REMARKS

Response To Drawing Objections

Annotated Drawing sheet

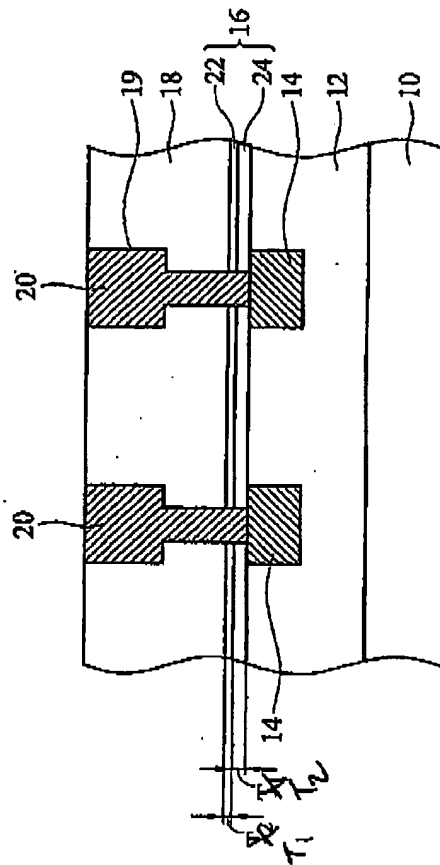
The drawings were objected to for certain inconsistencies between the specification and the drawings. Replacement sheets are included in this response to correct the inconsistency between the specification and the drawings. Especially, labels T₁ and T₂ in Fig. 2 are interchanged as the Examiner has recommended, and "5.6x10⁹" of Example III in Attachment is changed into "5.6x10⁸."

The Applicant believes that the drawings reflected in the replacement sheets overcome the objection.
